# TECHNICAL BULLETIN

## PROVISIONS FOR DRAINAGE OF WATER ENTRAPMENT AREAS

All 369H Series Helicopters

The information given in this Service Information Notice lists a procedure for incorporating drainage provisions in specified flight control components, to reduce the possibility of corrosion due to water entrapment.

**Figure 1. Drainage Provisions - Water Entrapment Areas**

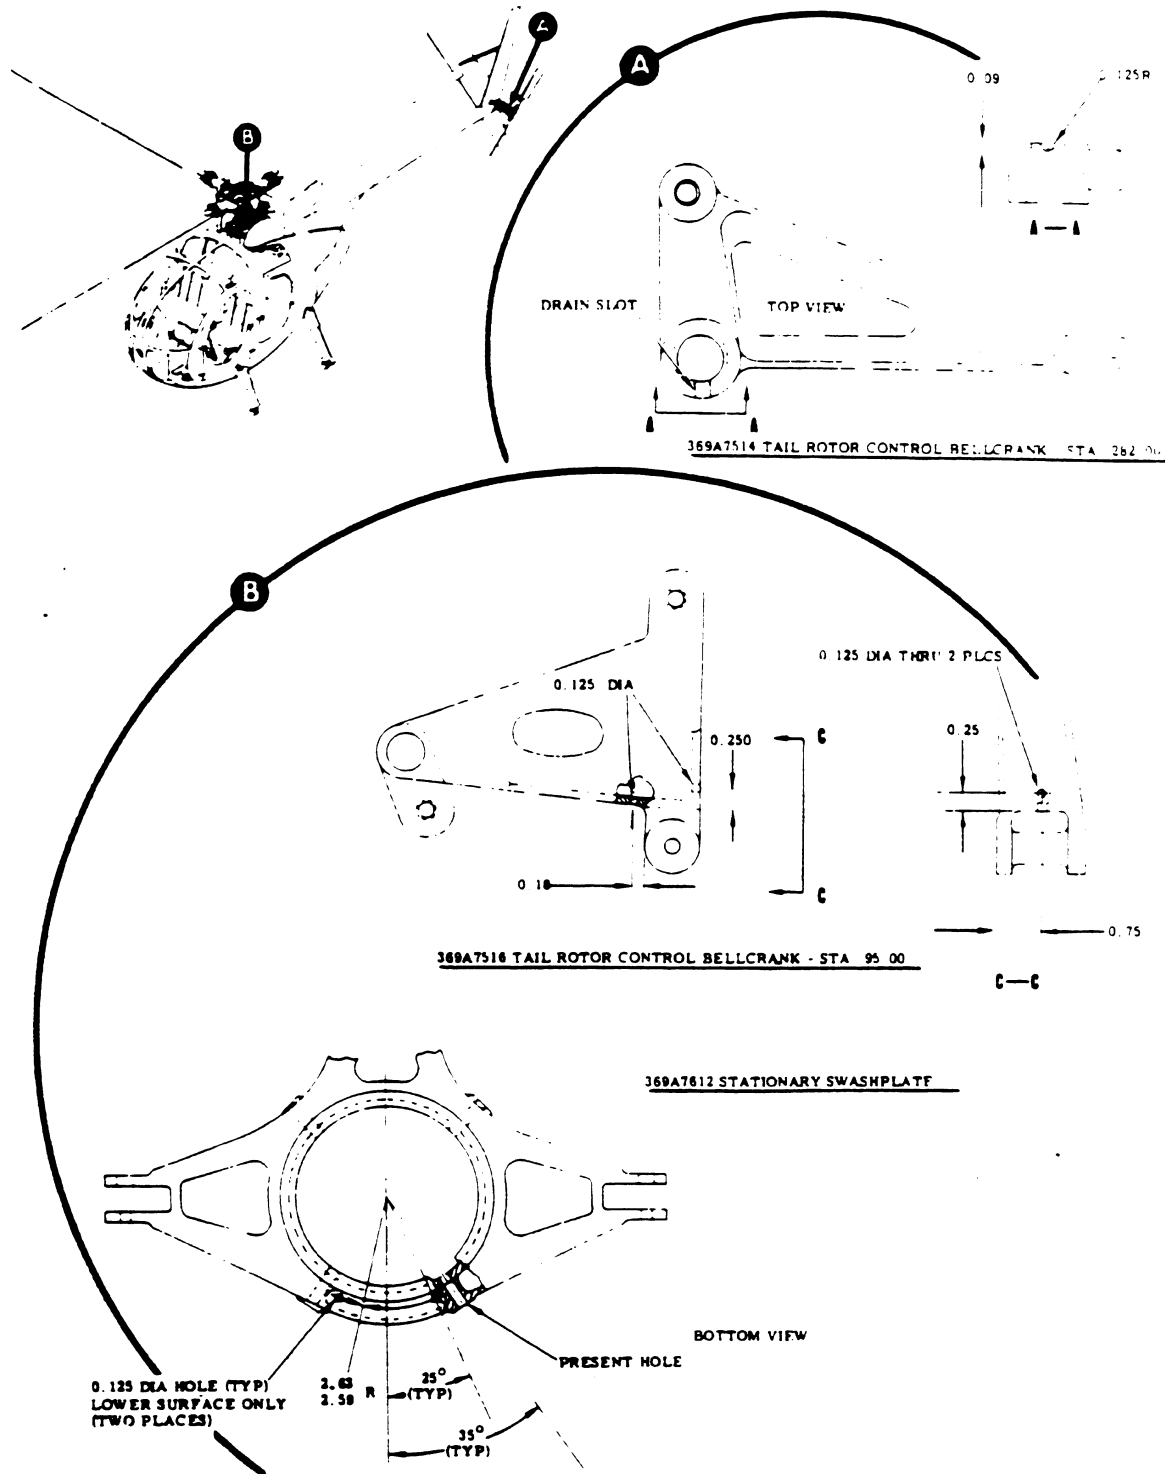
- a. Remove Sta. 282 bellcrank, per Section 8 of Basic HMI
- b. Using arbor press and appropriate tool, press out 369A7951-25 pivot Do not apply pressure to bearing inner race.
- c. Using a rat tail file (1/4-inch diameter), file the slot to dimensions shown in Figure 1; remove any discernible file marks with 400 grit paper wrapped around a 1/4-inch diameter dowel.
- d. Provide magnesium surface touch up treatment, per Section 2 of the Basic HMI; and paint touch up, per applicable HMI Configuration Supplement.
- e. Replace the pivot bearing as follows:
  1. Clean faying surfaces of bearing and bellcrank with trichloroethane; do not allow trichloroethane to enter bearing face.

- a. Remove Sta, 95 bellcrank, per Section 8 of Basic HMI.
- b. Drill two 0.125 inch diameter holes at dimensions shown in Figure 1; deburr holes and remove any shavings.
- c. Provide magnesium surface touch up treatment, per Section 2 of Basic HMI; and paint touch up per Section 2 of applicable HMI Configuration Supplement.
- d. Reinstall Sta. 95 bellcrank, per Section 8 of Basic HMI.

- a. Remove stationary swashplate, per Section 7 of Basic HMI.
- b. Drill two 0.125 inch diameter holes at dimensions shown in Figure 1; deburr roles and remove any shavings.
- c. Provide magnesium surface touch up treatment, per Section 2 of Basic HMI; and paint touch up, per Section 2 of applicable HMI Configuration Supplement.
- d. Reinstall stationary swashplate, per Section 7 of Basic HMI.
